CITY OF CORCORAN
Corcoran Planning Commission Agenda
September 1, 2022 - 7:00 pm

Planning Commission Meeting: September 1, 2022	Prepared By: Natalie Davis McKeown
Topic: Brown Riding Arena CUP (City File. No. 22-047) 22640 Oakdale Drive (PID 05-119-23-13-0006)	Action Required: Recommendation

Planning Commission Meeting: September 1, 2022	Prepared By: Natalie Davis McKeown
Topic: Pro-Tech Auto Expansion Site Plan, Conditional Use Permit, and Variance (PID 26-119-23-11-0020) (City File No. 22-048)	Action Required: Recommendation

Job Number:	22004
Field Date:	3/18/22
Drawing Name:	Brown-08-11-22.dwg
Drawn by:	DMS
Revisions:	6/7/22 (vacate easement)
	6/22/22 (prop. barn), 7/12/22 (prop. arena)
	8/11/22 (prop. grading detail)

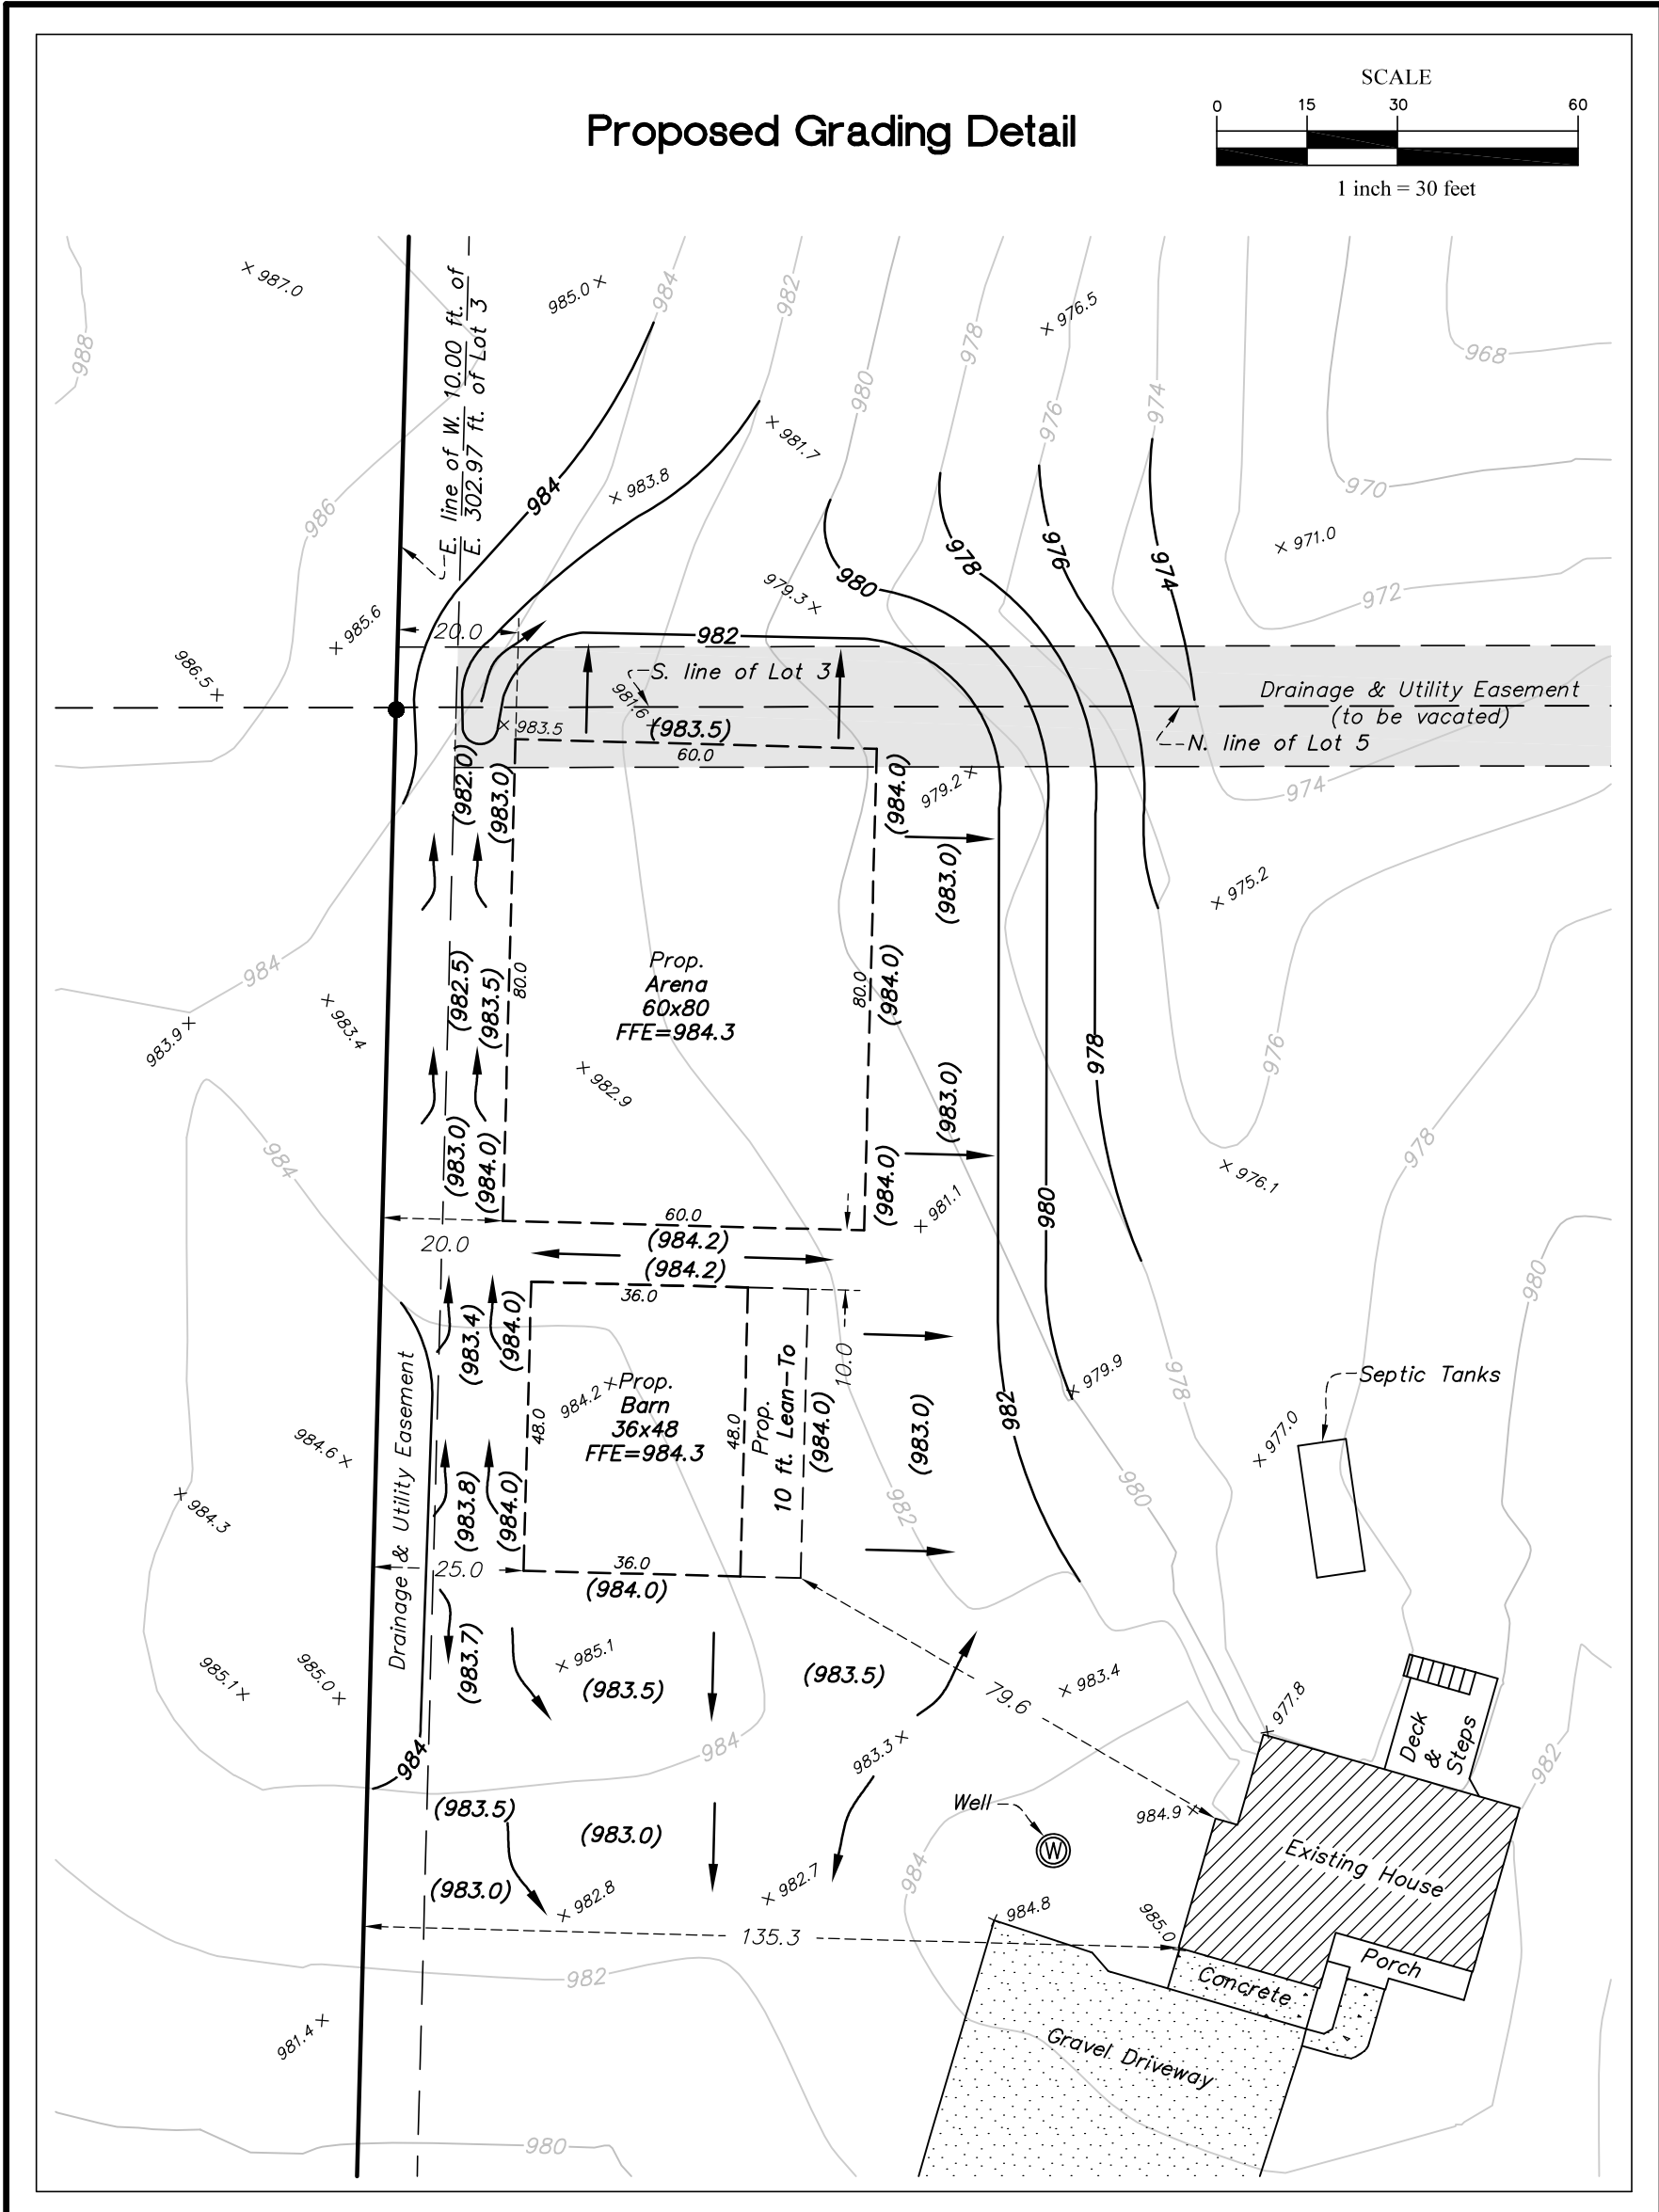
- The grading shown on plan sheet dated 8-11-22 by Whitetail Land Surveying is approved for drainage and grading.

1
A2 LEFT ELEVATION
1/4" = 1'-0"

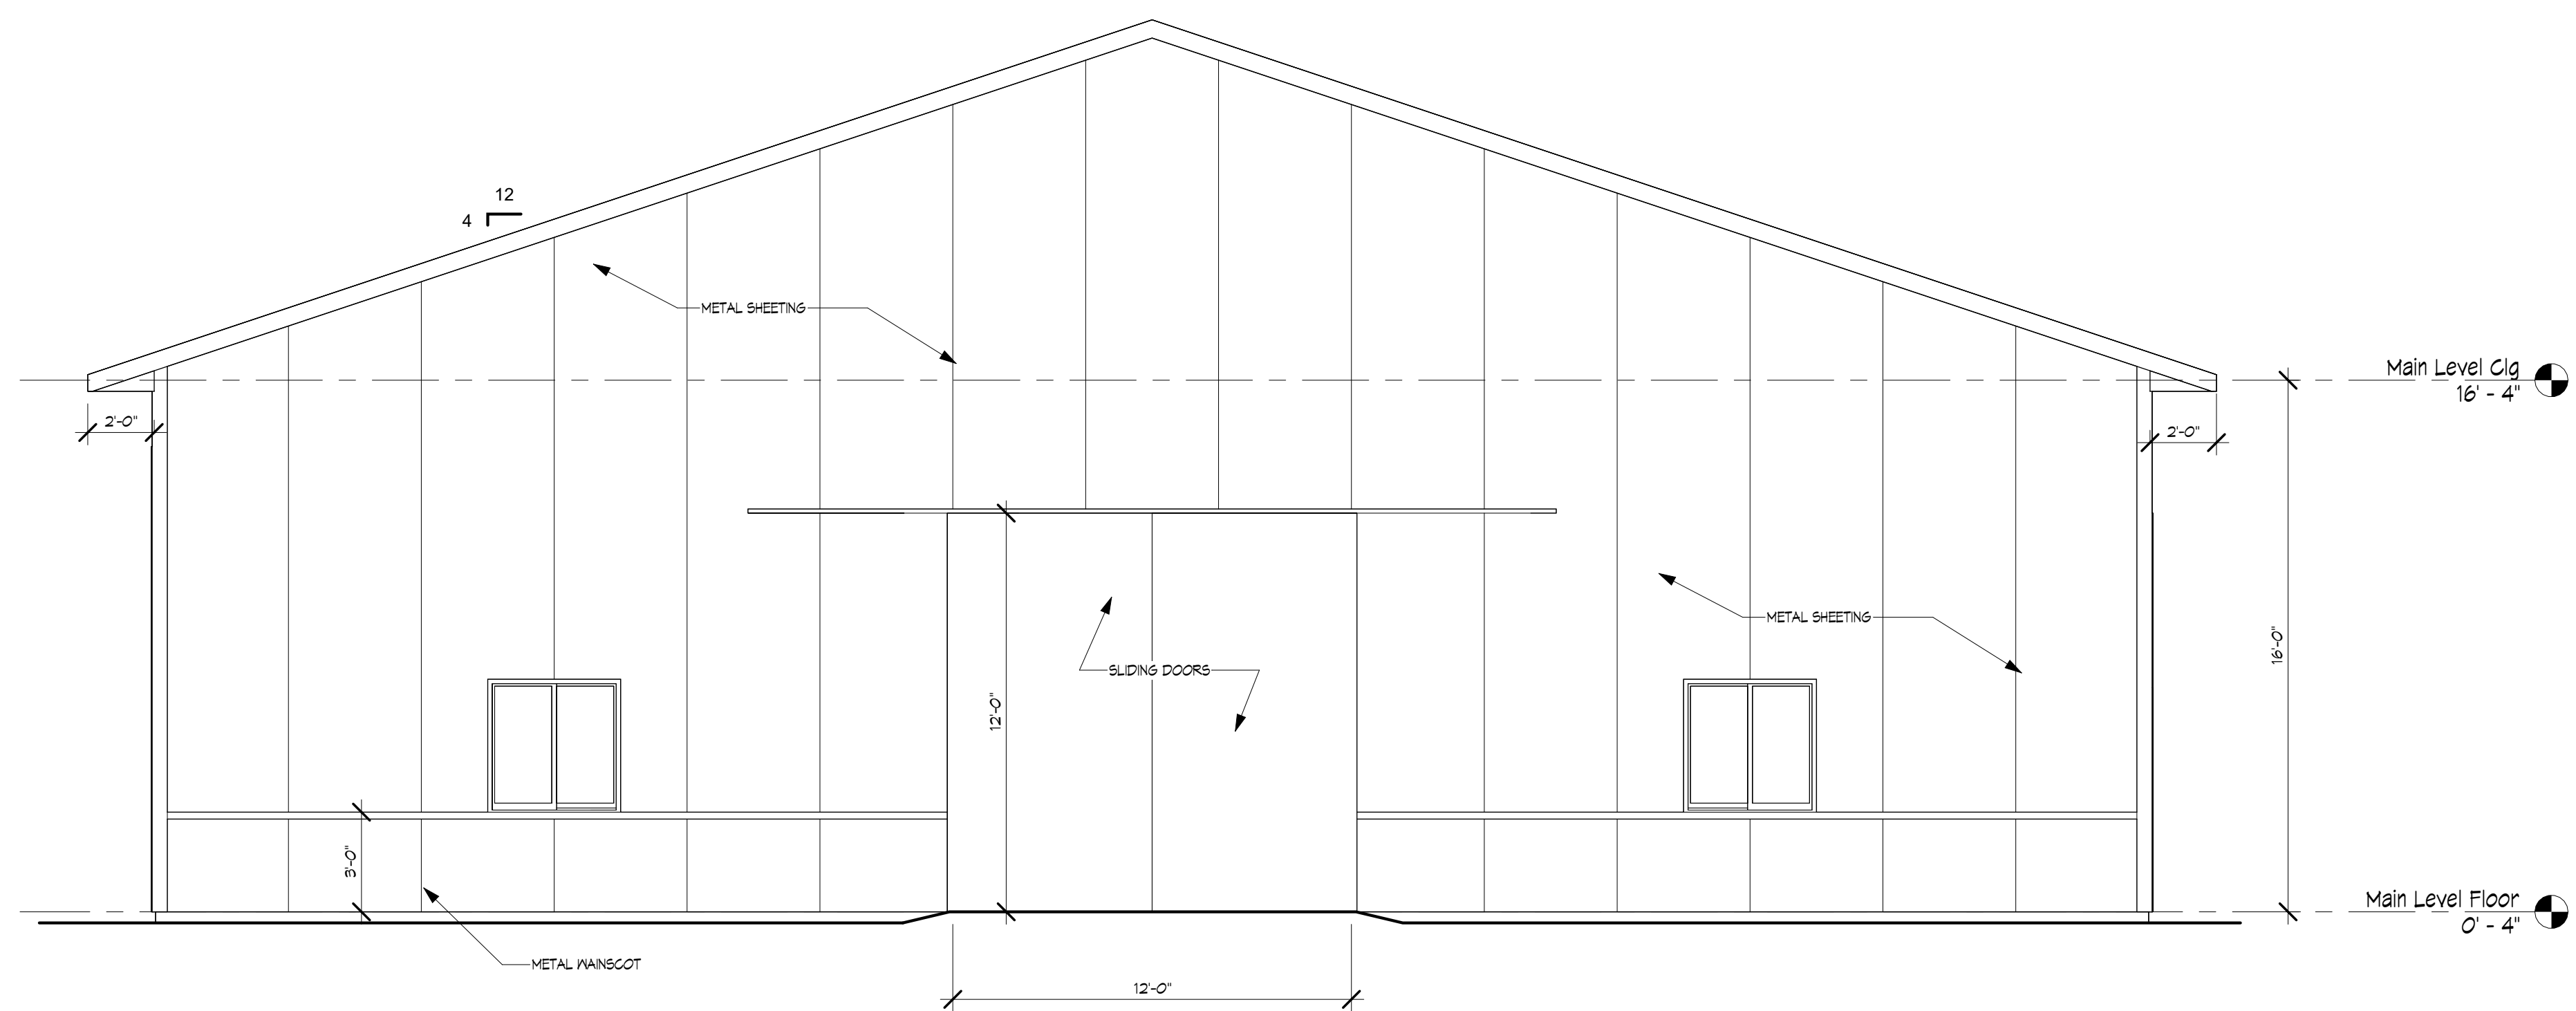
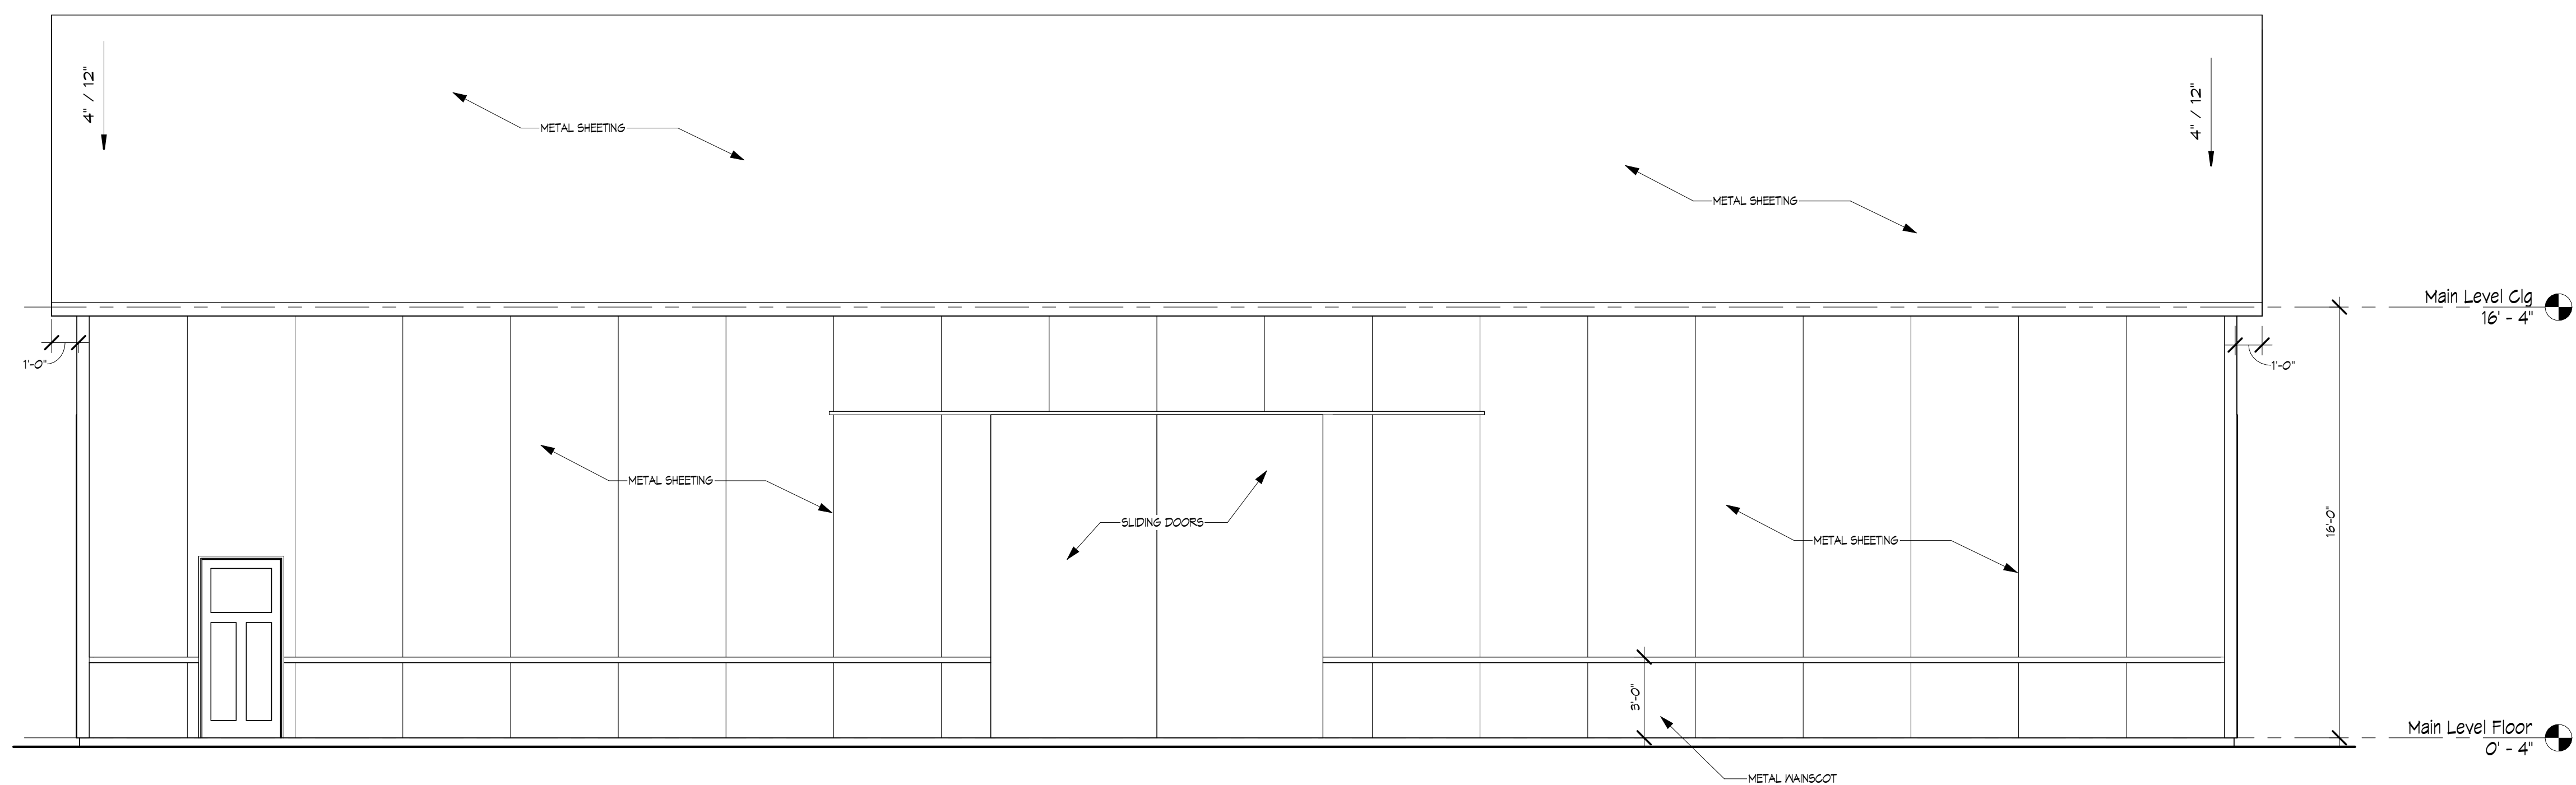
The plans for the riding arena show a sidewall height of 16'4". Accessory structures located in the rear yard are allowed a sidewall height of up to 13'6" by right. However, all properties can request to exceed this height through a CUP, so the height of the building has been added as part of the CUP request which is discussed in more detail below.

Buildings with a sidewall height of more than 12' require a minimum eave of 12" and minimum overhang of 24". Unfortunately, the City Code does not specifically define eaves or overhang, and often these terms are used interchangeably. Historically, staff interpreted eaves to mean the underside or soffit of the roof along the side of the building. Overhangs have been interpreted to mean the edge of the roof overhanging the front and rear elevations. Under these interpretations, the plans show a 1' overhang and eaves of 2'. For the sake of consistency in how previous plans have been approved, the plans should be revised so that the overhang meets

the 2' minimum. This has been added as a condition of approval in the draft Resolution.

- a. Revised plans must be submitted to satisfy the overhang minimum of 24 in.
 - b. The applicant must continuously comply with the manure management standard in paragraph 8 of Chapter 81.11 of the City Code.
